**RE: Casitas Del Camino
Conceptual Grading & Drainage Plans
Engineer's Stamp Date: 08/15/24
Hydrology File: K11D080**

CONCEPTUAL GRADING & DRAINAGE PLAN

CASITAS DEL CAMINO

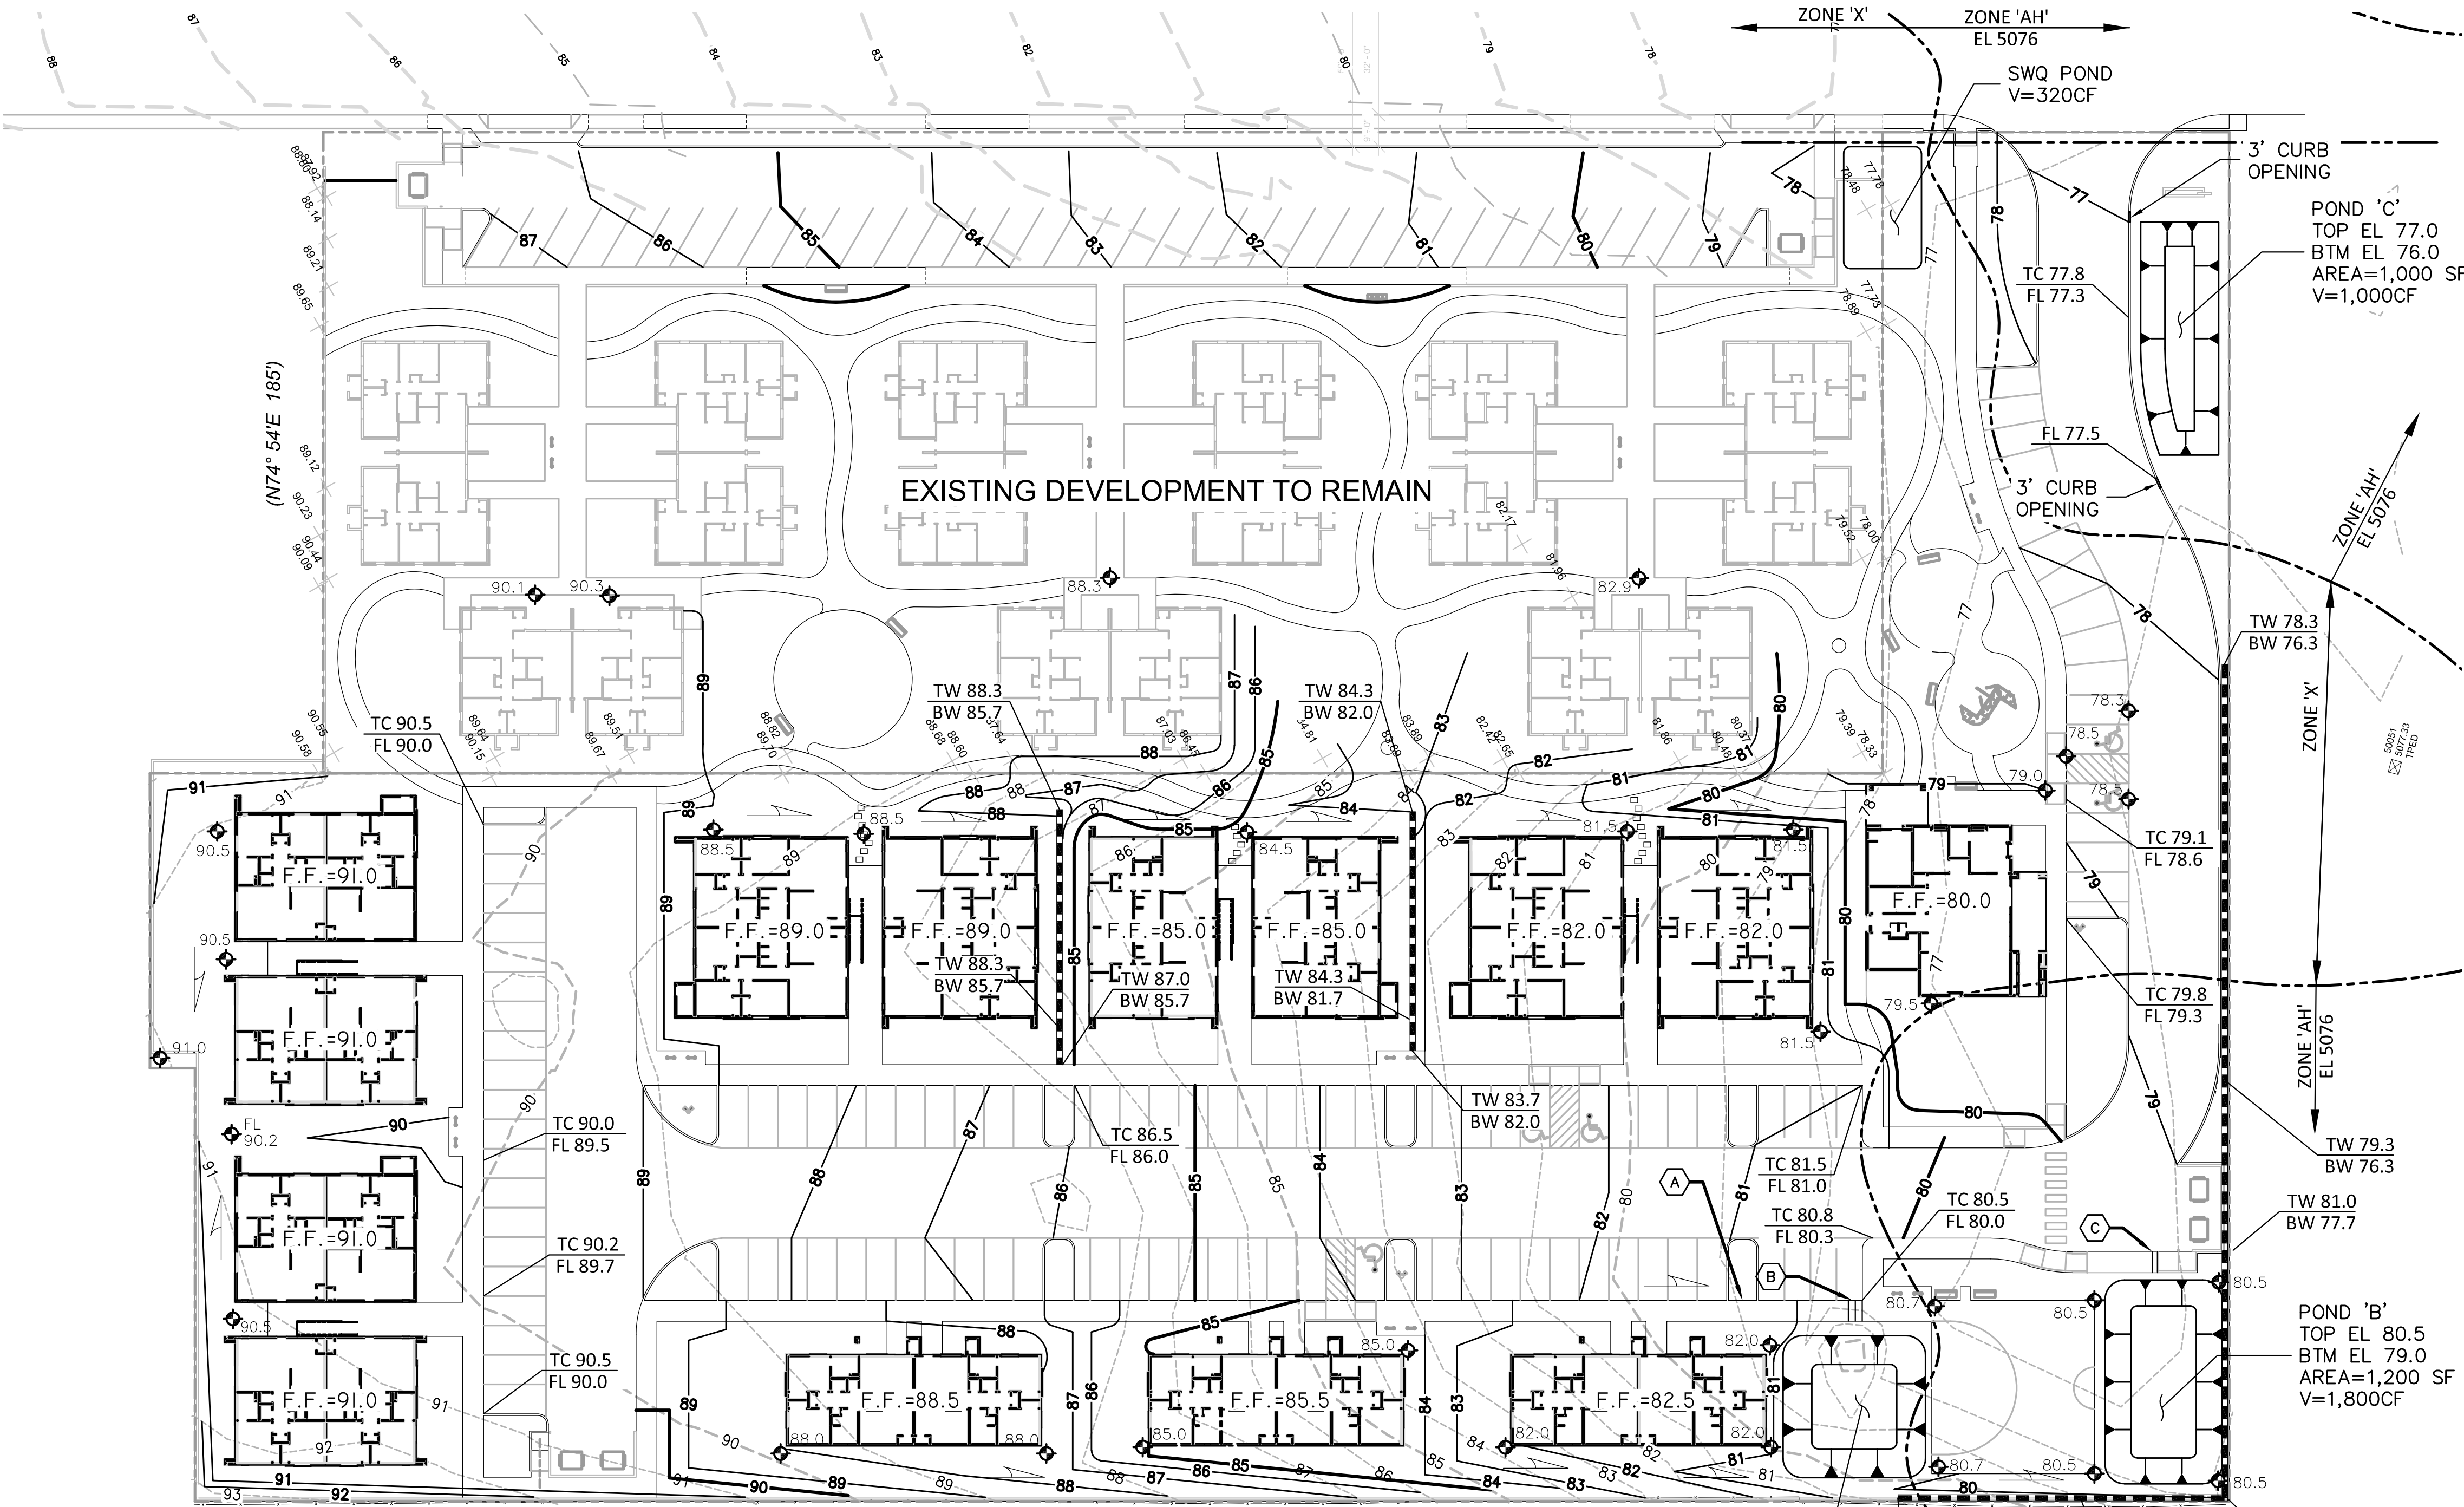
- 1) All existing buildings and walks have been shown with lighter linework to differentiate it from the proposed work.
- 2) The LOMA is now referenced in the drainage narrative.
- 3) The proposed contours have been revised within the street to direct runoff toward the SWQ pond. An additional SWQ pond has been added near the project entry.
- 4) The FEMA flood zone boundaries have been added and noted near the 60th Street entry and along the south property line.
- 5) The project entry has been revised to the north on 60th Street.
